# International Isotopes Inc.

Subject: Submittal of Responses to Requests for Additional Information (RAI)  
TAC L32739.

The following document is provided as a response to the US Nuclear Regulatory Commission RAIs pertaining to the International Isotopes Fluorine Products Inc. December 30, 2009 application to license a depleted uranium hexafluoride de-conversion and fluorine extraction process facility.

<b>BUILDING</b> (Areas where uranium is processed or stored are marked in "bold print")	<b>DIMENSIONS</b> (feet)	<b>APPROXIMATE AREA</b> (square feet)	<b>APPROXIMATE VOLUME</b> (cubic feet)
---	--------------------------	---------------------------------------	--

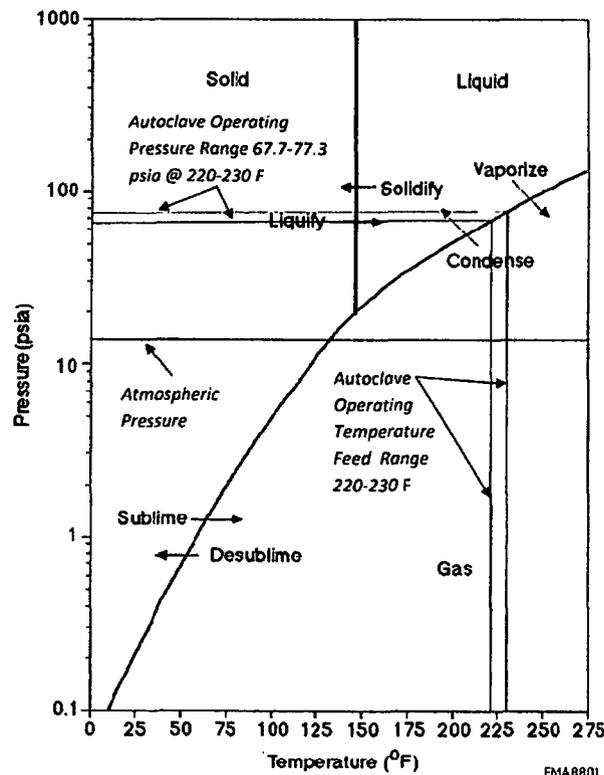
**License Documentation Impact:** The original Table 1-1 in Section 1, "General Information", Revision A of the IIFP License Application is being deleted in total and a new Table 1-1 is being added as shown below. The original paragraphs six (also modified in response to RAI GI-2) and seven along with Table 1-1 will read as follows (black text is original and red text is change or new). See also RAIs GI-2, GI-6A, and GI-7A.

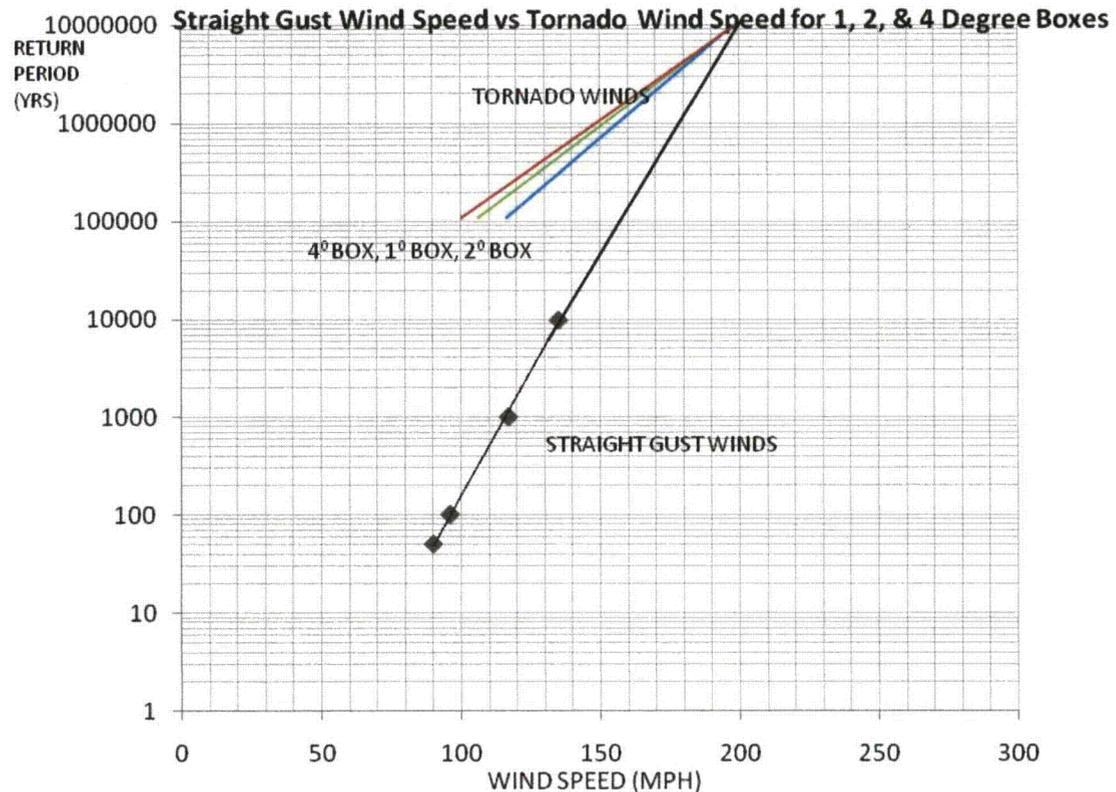
D. For the design basis wind strength in the ISA Summary, provide a return year period and maximum wind speed for both intermediated term (100-500 years) and long term (>1000 years). Specify the basis for both the maximum wind speed and return year period for the information, e.g., a site-specific study, national weather service, etc. In addition, Table 3-22 in the ER has a very limited timeframe (82-97). Justify that this limited timeframe is adequate for the design basis wind. Demonstrate that the wind assessments were from a recognized source and the method used for analyzing high-wind hazard is a commonly used and accepted method.

**RESPONSE:** The determination of design basis wind speed has been reevaluated using a different methodology and under a different set of criteria than those addressed in Question GI-10 D. A discussion of that methodology is provided in this response.

The evaluation of tornadoes and straight winds was made based on NUREG/CR-4461, Revision 2 (February, 2007) including data in Appendices A, B and C of the NUREG. This NUREG guide provides calculations based upon 46,800 tornado segments occurring from January 1, 1950 through August 2003 of which more than 39,600 had sufficient information on location, intensity, length, and width to be used in the analysis included in this report. NUREG/CR-4461, Revision 1 had been published in April 2005. The National Weather Service changed from using the Fujita Scale to the Enhanced Fujita Scale in February 2007. Revision 2 incorporates the Enhanced Fujita Scale in its methodology and calculations. Specifically, Chapter 5 of the NUREG has been revised to show  $1 \times 10^4$ ,  $1 \times 10^6$ , and  $1 \times 10^7$  probability design wind speeds (i.e., probability of exceeding that wind speed in one year) for the contiguous United States estimated using the above database and the Enhanced Fujita Scale. (NCDC, 2010b)
